Access Compliance Report

Public Rights-of-Way

(Pedestrian Signals)

Intersection ID: N/A	Main Street:	Cross Street: N/A	Location: N/A
ADA ID: E3C6CE5A6338	Signal Type: One Push Button-Non APS	Overall Compliance: No	Severity Score: BTN 1: N/A BTN 2: N/A No BTN: N/A
Codes/Mitigation Info/Possible Solution		Field Measurements/Component Compliance

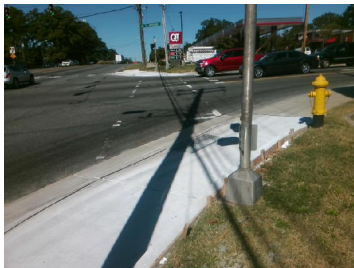
Surveyor Notes: TX HT 1/4

PROW/ADA: R410.6, TMUTCD 4e.08, R406.2, R404.7.3

Possible Solutions: Replace Signal Push Button With APS Button on New Post. Remove & Replace Sign.
